**EPA Superfund
Explanation of Significant Difference
for the Record of Decision:**

**Teledyne Wah Chang
Albany, OR
10/8/1996**

EXPLANATION OF SIGNIFICANT DIFFERENCES

**From the June 10, 1994 ROD For Final Remedial Action Of Groundwater and
Sediments Operable Unit**

FIGURE 1
LOCATION MAP

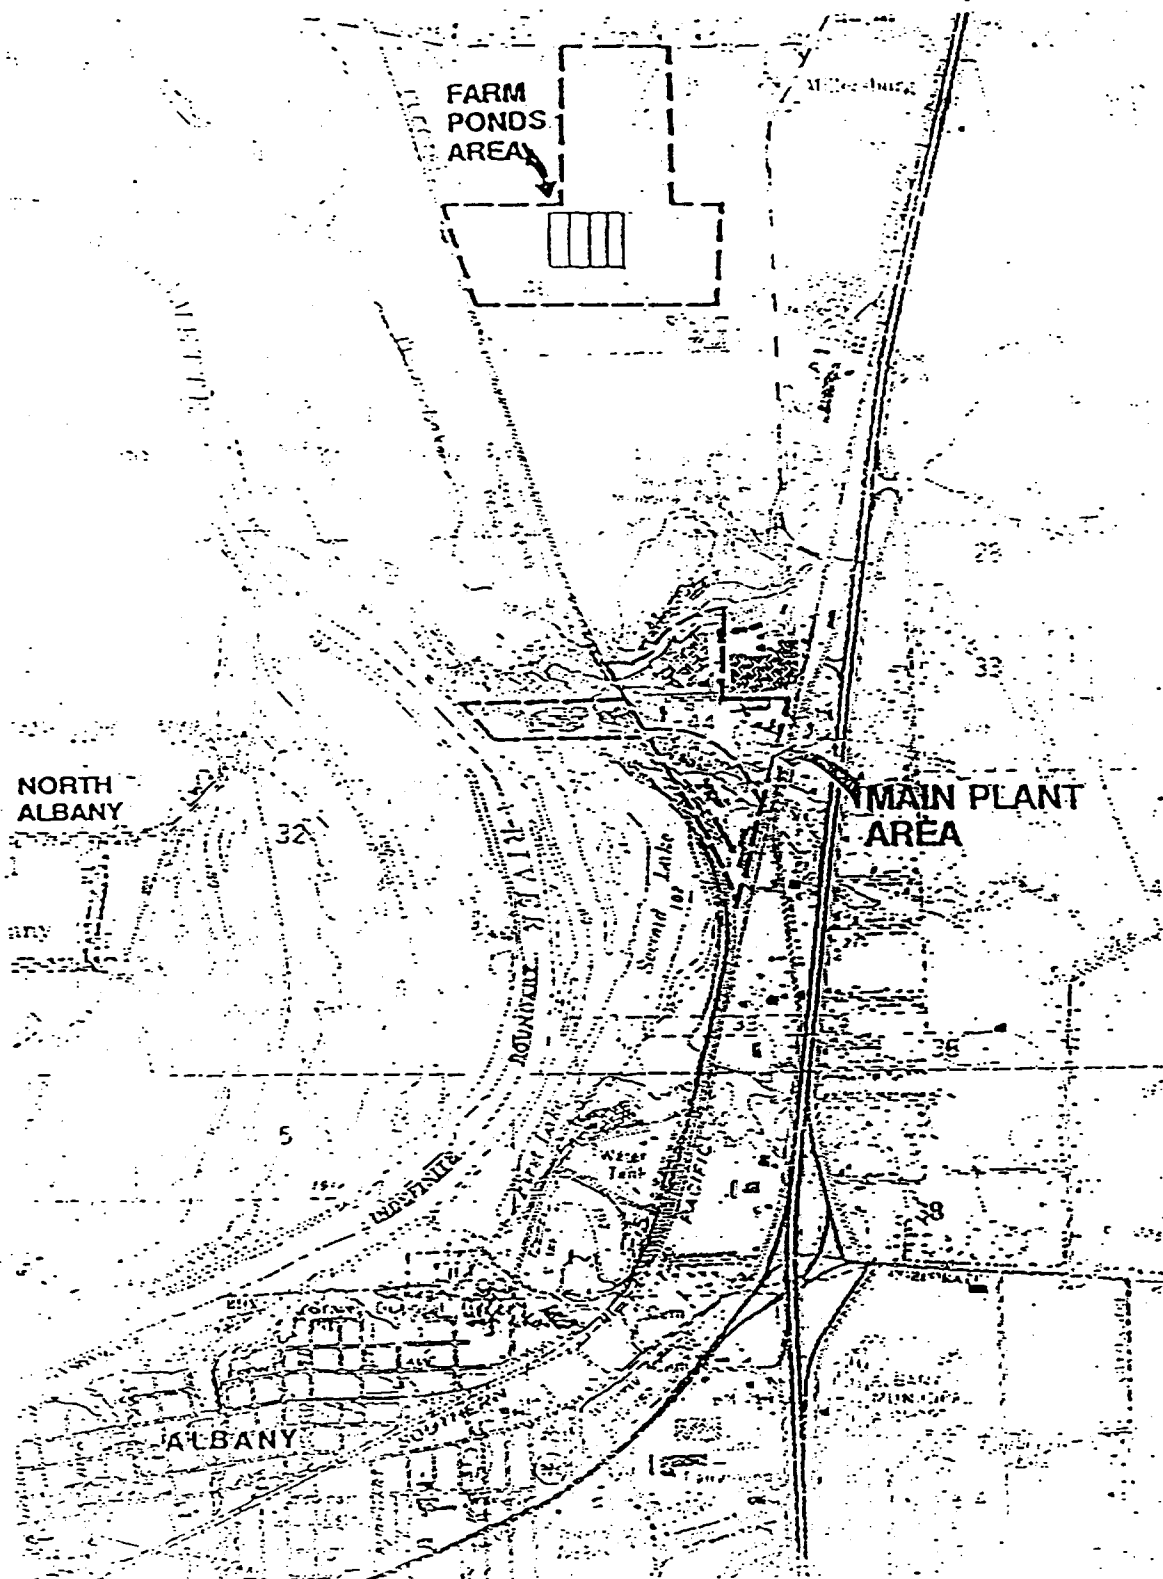
The Teledyne Wah Chang Albany (TWC) site is located in Millersburg, Oregon, adjacent to the city of Albany. The facility covers approximately 225 acres near the Willamette River. The TWC facility is divided into a 110-acre main plant area and a 115-acre Farm Ponds area (Figure 1).

Within the Farm Ponds Area, the soil amendment area is a 47.8-acre agricultural tract located directly north of the Farm Ponds (Figure 1). In 1976 TWC placed solids from their wastewater treatment plant in this area to be used experimentally as a soil amendment. The solids were similar in composition to that of the LRSP and Schmidt Lake. Surface soil samples taken from the soil amendment area during the RI contained PCBs, SVOCs, and radionuclides.
